Agenda
Village of Arlington Heights
Design Commission
Community Room, 3rd Floor

Arlington Heights Village Hall
33 S. Arlington Heights Road
Arlington Heights, IL 60005
March 29, 2016
6:30 PM

**MINUTES OF
THE VILLAGE OF ARLINGTON HEIGHTS
DESIGN COMMISSION MEETING
HELD AT THE ARLINGTON HEIGHTS MUNICIPAL BUILDING
33 S. ARLINGTON HEIGHTS RD.
MARCH 8, 2016**

RIGHT SIDE ELEVATION

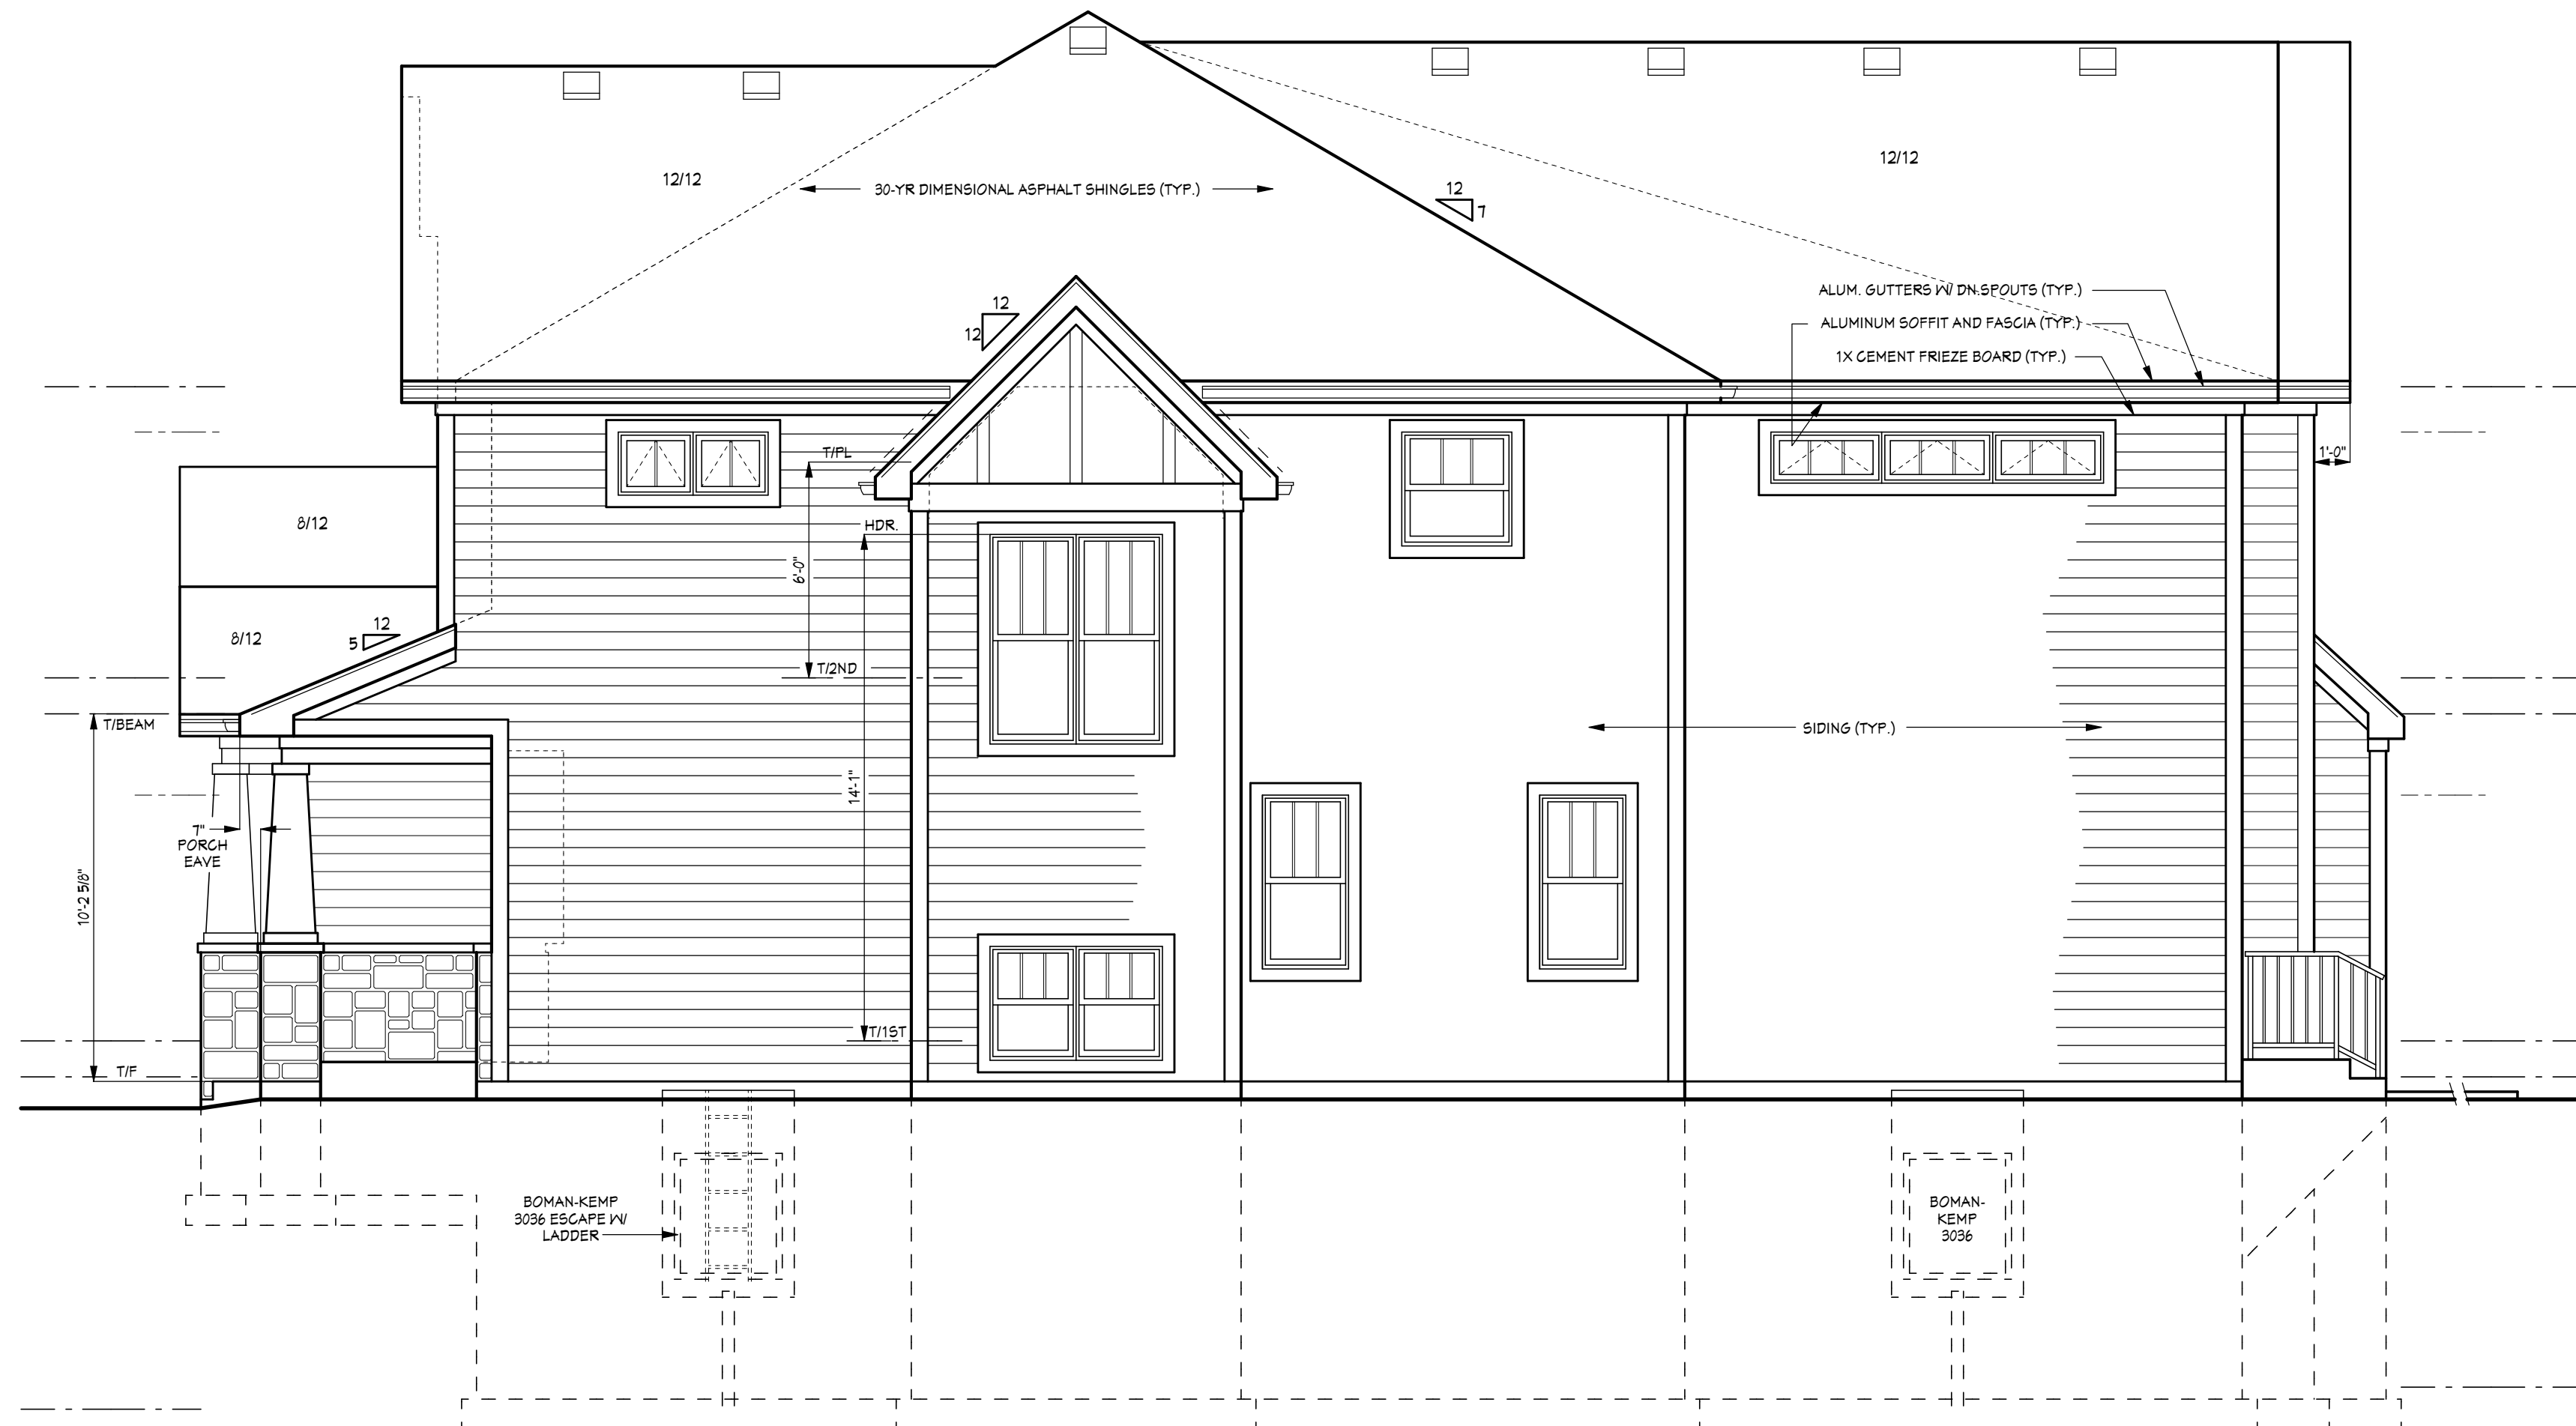
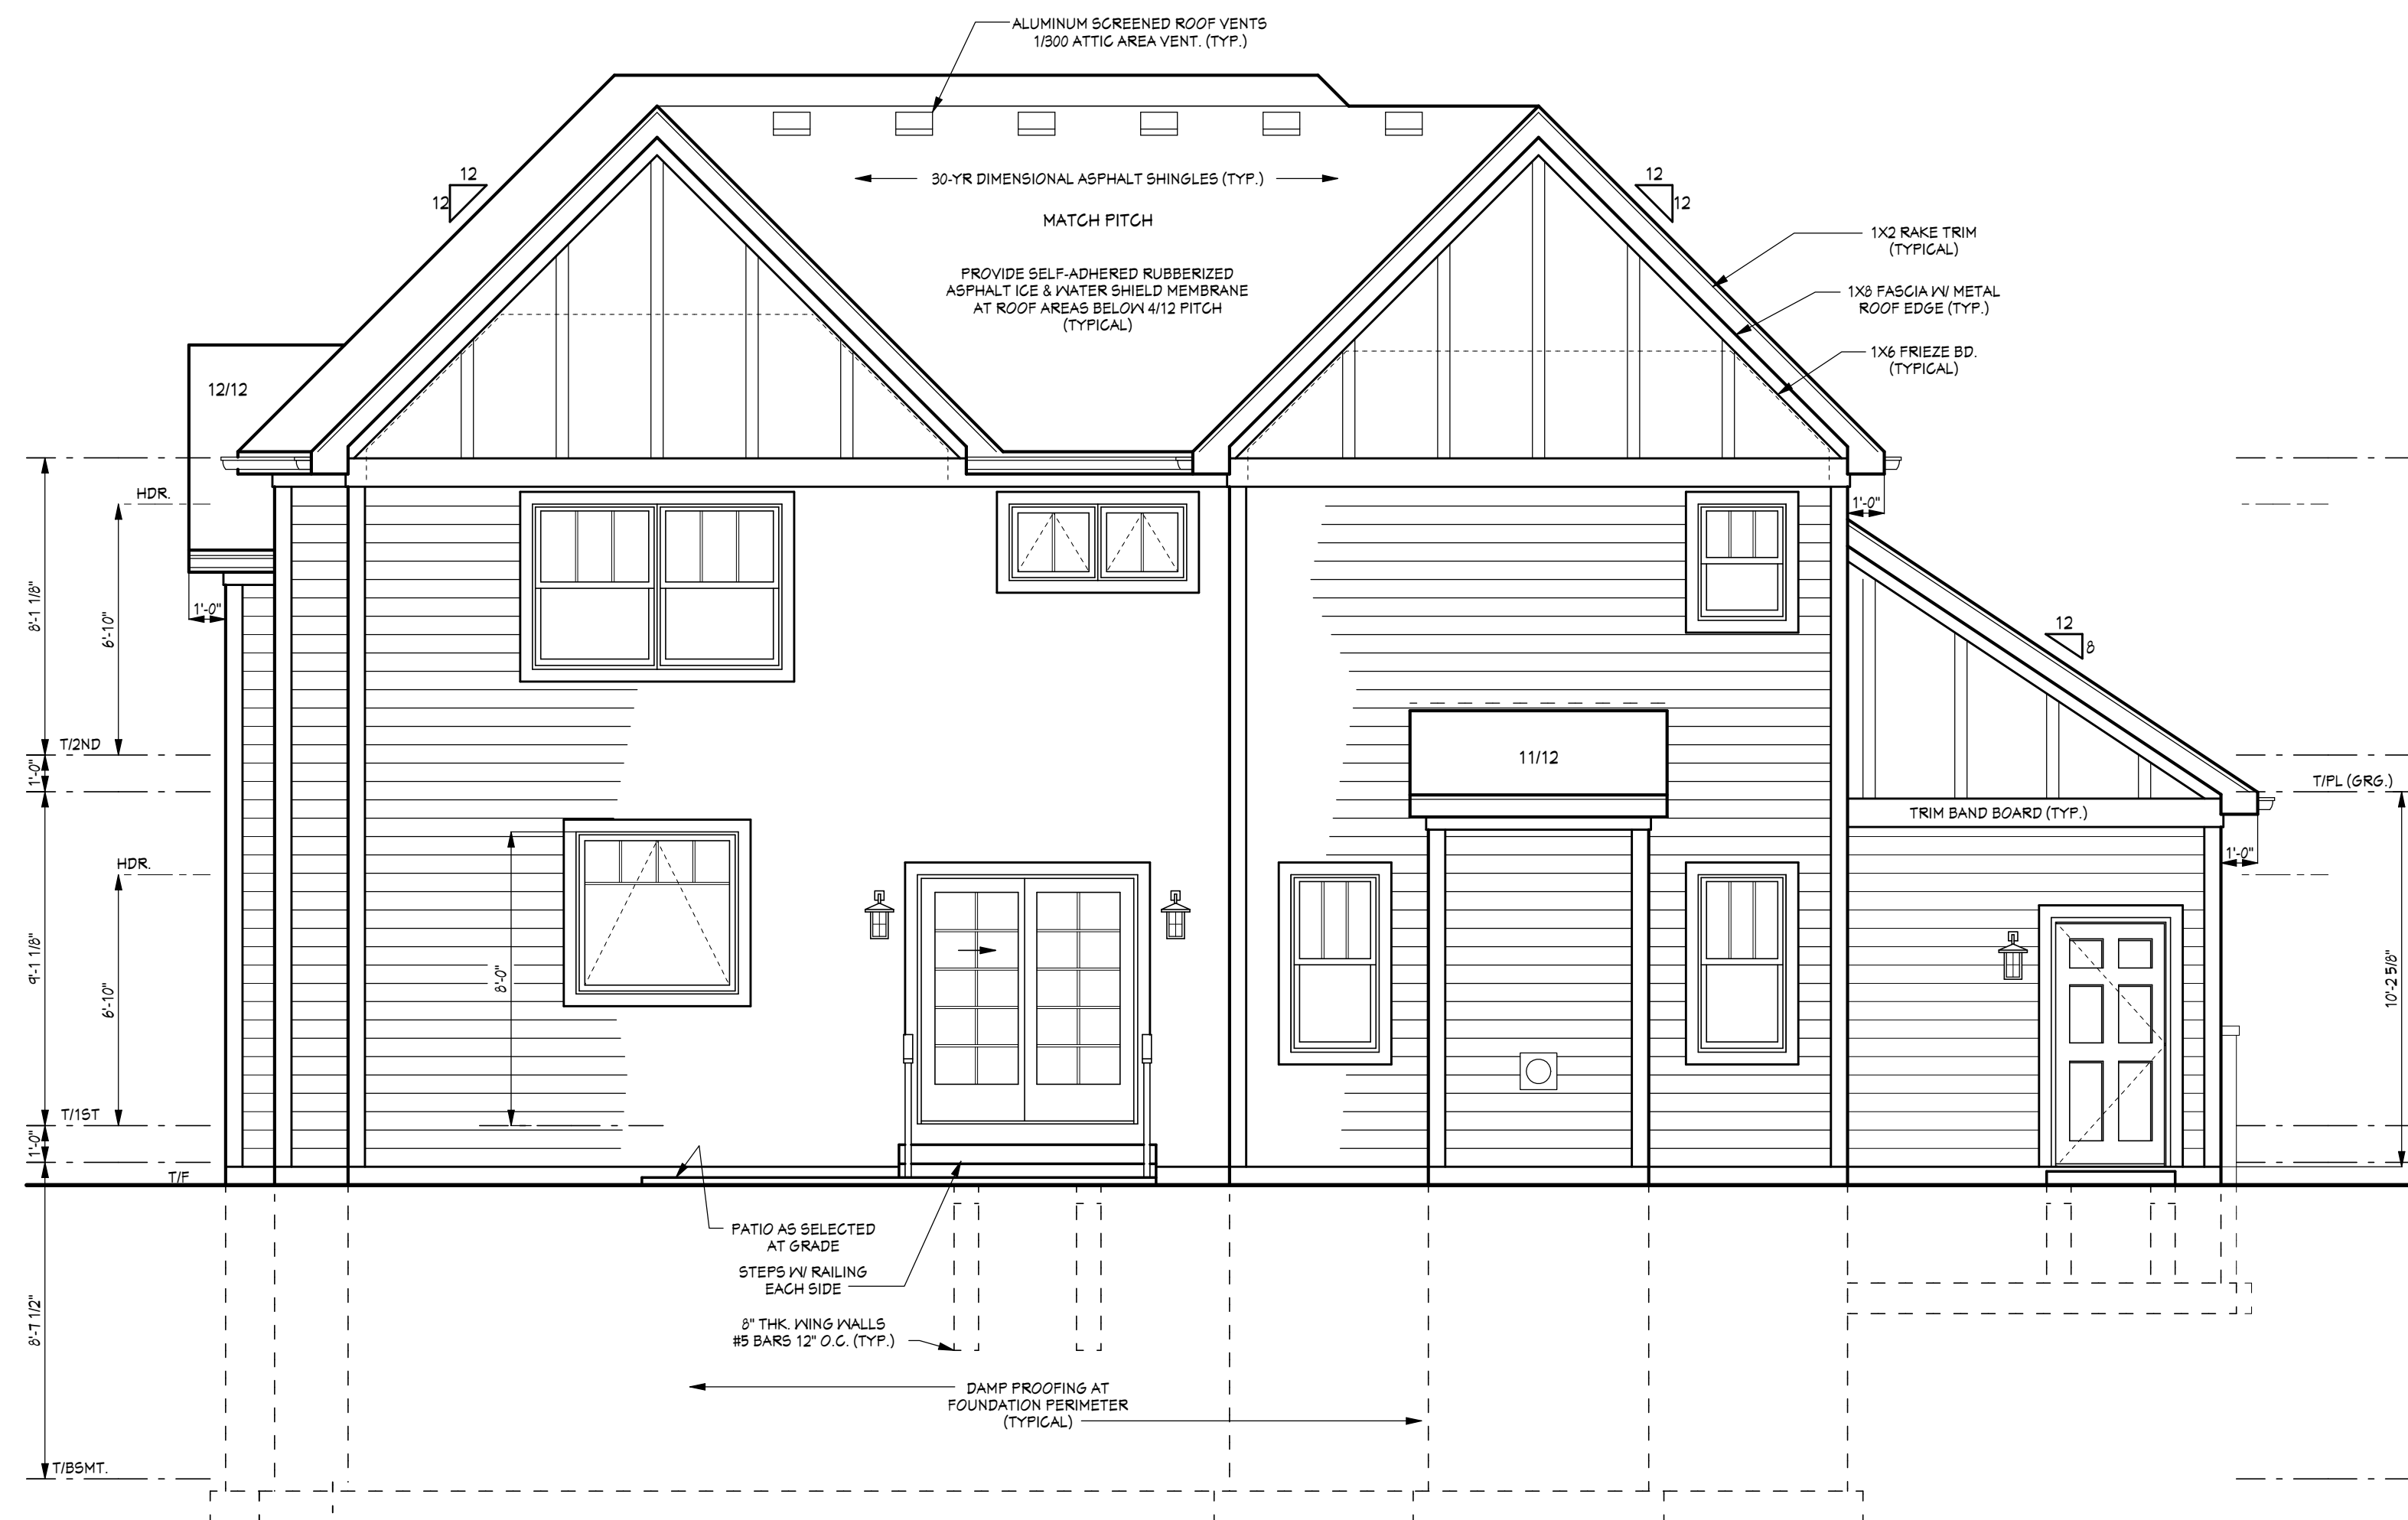
1. Add additional windows to the side elevations to help break up the wall area.
2. This review deals with architectural design only and should not be construed to be an approval of, or to have any other impact on, any other zoning and/or land use issues or decisions that stem from zoning, building, signage or any other reviews. In addition to the normal technical review, permit drawings will be reviewed for consistency with the Design Commission and any other Commission or Board approval conditions. It is the architect/homeowner/builder's responsibility to comply with the Design Commission approval and ensure that building permit plans comply with all zoning code, building permit and signage requirements.
3. Compliance with all applicable Federal, State, and Village codes, regulations and policies.
